M/023/003

RE: Response to Division Comments on Second Review of Brush Resources Inc.'s NOI
Amendment for Topaz Mine, Juab County, Utah; M/023/003

**COMMENT RESPONSE SUMMARY
DOGM LETTER OF NOVEMBER 17, 2005**

Brush Resources, Inc.
 Surface Facilities Map

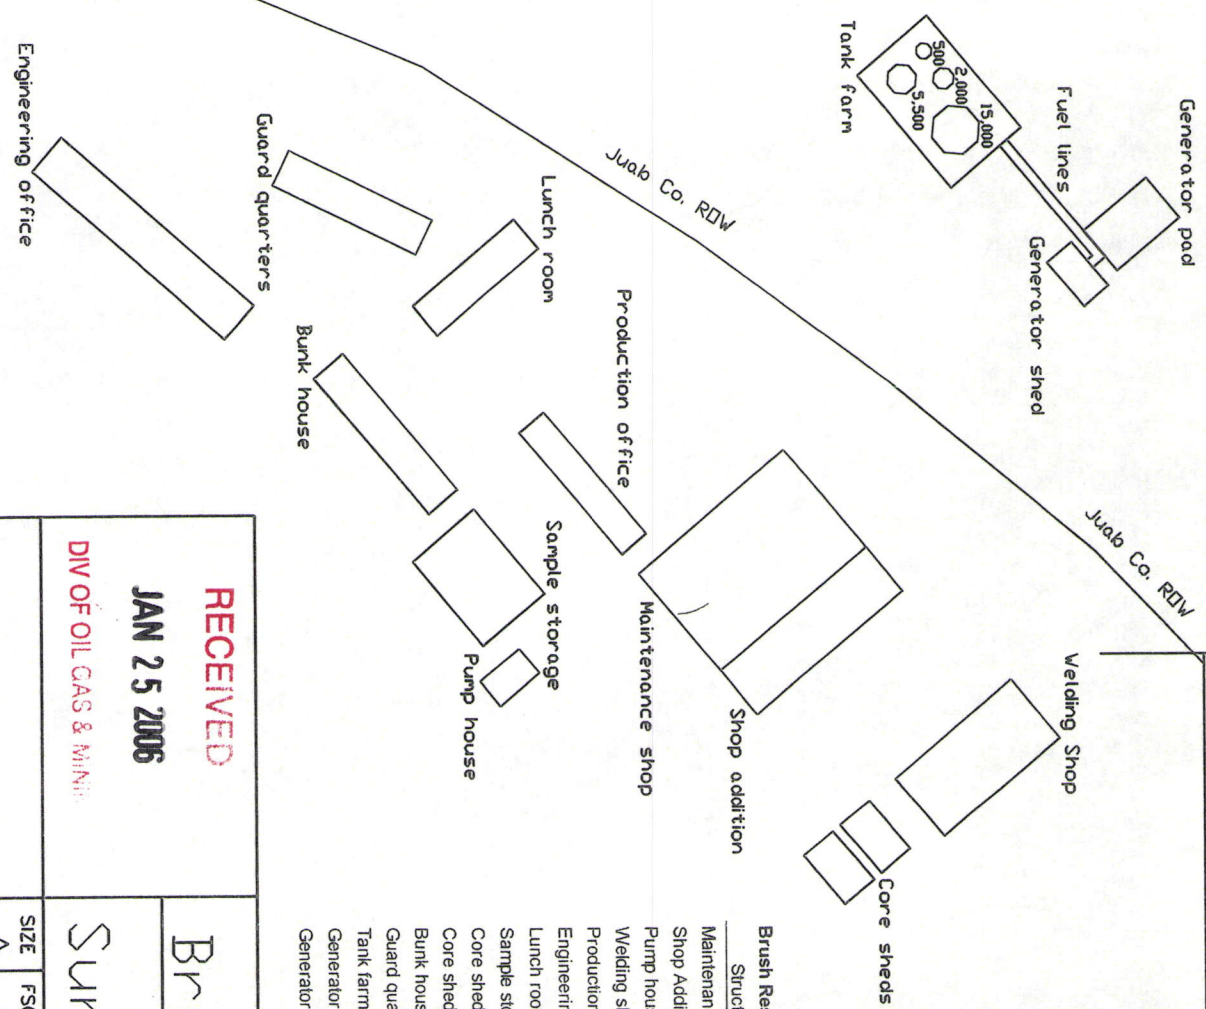
A surface facilities map for the camp area at a scale of 1" = 60' has been prepared and is attached for the Division's review and approval.
